# Access Compliance Report

## Public Rights-of-Way

### (Curb Ramps)

Intersection ID: 42781	Main Street: SAWMILL_TRACE_DR	Cross Street: SILVERSWORD_DR	Location: NE
ADA ID: B2F5AC40CF43	Ramp Type: Perp	Initial Pass/Fail: Pass	Overall Compliance: No
			Severity Score: 17.75

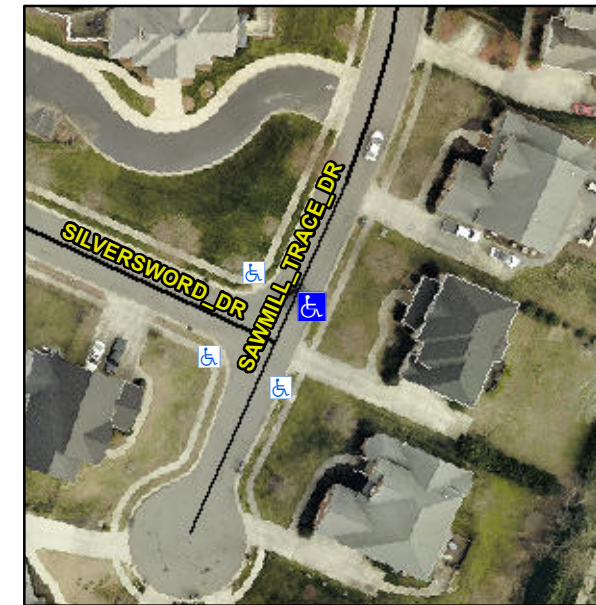
**Not Found, R304.5.3, R304.2.2-Perp,  
R304.3.2-Para, R305, R302.7.2**

Compliance	Description	Data	Compliance	Description	Data
N/A	Ramp Length (in)	47.5	Yes	Ramp Slope (%)	7.6
Yes	Ramp Width (in)	50.0	No	Ramp XSlope (%)	2.7
N/A	Flare Type LT	Sloped	N/A	Flare Type RT	N/A
N/A	Flare Slope LT (%)	1.8	N/A	Flare Slope RT (%)	8.2
N/A	Flare Traversable LT?	No	N/A	Flare Traversable RT?	No
Yes	Landing Length (in)	48.0	No	DWS Provided?	No
Yes	Landing Width (in)	50.0	N/A	DWS Contrast?	No
No	Landing Slope (%)	2.3	N/A	DWS Length (in)	N/A
Yes	Landing X Slope (%)	2.5	N/A	DWS Full Width?	No
N/A	Landing Curb? (Y/N)	No	N/A	DWS Offset (in)	N/A
N/A	Shared Landing?	No			
Yes	Gutter Ponding?	No	Yes	Gutter Slope (%)	1.5
No	Gutter Lip Ht (in)	0.5	No	Gutter X Slope (%)	4.1
N/A	Painted X Walk1?	No	N/A	Painted X Walk2?	N/A
	X Walk 1 Direction	To NW		X Walk 2 Direction	N/A
N/A	X Walk 1 Width (in)	N/A	N/A	X Walk 2 Width (in)	N/A
	X Walk 1 Slope (%)	3.1		X Walk 2 Slope (%)	N/A
	X Walk 1 X Slope (%)	2.5		X Walk 2 X Slope (%)	N/A

**Remove & Replace Entire Ramp.  
Remove & Replace Gutter.**
